## REVISED RESPONSE TO REQUEST FOR ADDITIONAL INFORMATION

### APR1400 Design Certification

RAI No.: 390-8479  
SRP Section: 12.02 – Radiation Sources  
Application Section: 12.02  
Date of RAI Issue: 02/01/2016

### **Question No. 12.02-26**

Figure 1. Location of CR Emergency ACUs above the MCR

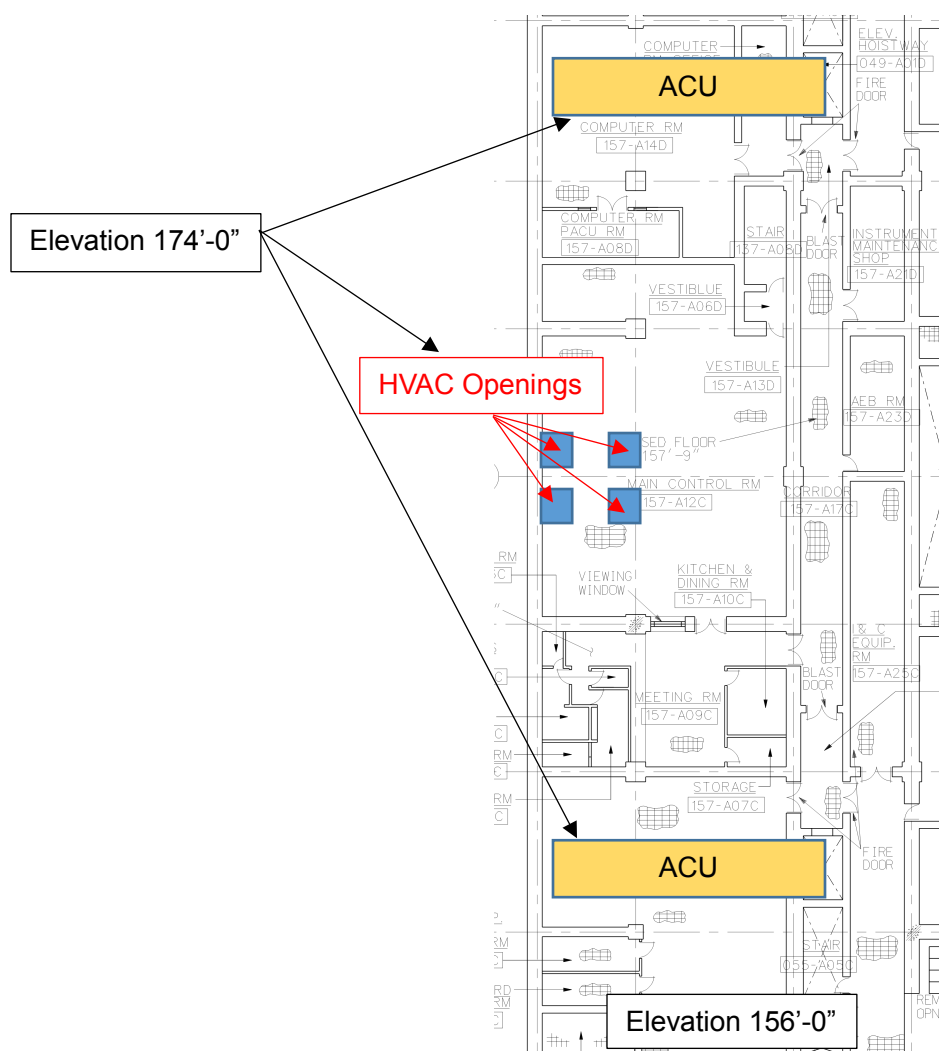
3. In the response, the applicant provides information indicating that containment penetrations will not be a significant dose contribution to CRE dose. Please specify if the design is such that it prevents a direct radiation streaming path or near direct radiation streaming path from the emergency filters (located above the main control room.) into the CRE through the ventilation ducting openings or other penetrations into the CRE.

- The two control room emergency air cleaning units, at elevation 174'-0", are not located directly above the main control room (MCR) at elevation 156'-0"; one is located above the computer room (plant north side of the MCR), and the other above the TSC room on the south side of the MCR. Their locations are indicated in the attached sketch (Figure 1) for illustration purposes. Based on these locations, the air supply and exhaust duct penetrations are designed to be located away from the CR Emergency ACU to prevent direct, or near direct, radiation streaming pathways. [The description on why the streaming from the ACUs is not considered will be added in Table 6.4-1.](#)

The two control room emergency air cleaning units (ACUs) are located above the computer room (plant north side of the MCR) and the TSC room on the south side of the MCR, respectively. Therefore, since the air supply and exhaust duct penetrations located above MCR are designed to be located away from the emergency ACUs, the direct, or near direct, radiation streaming through these penetrations is not a concern.
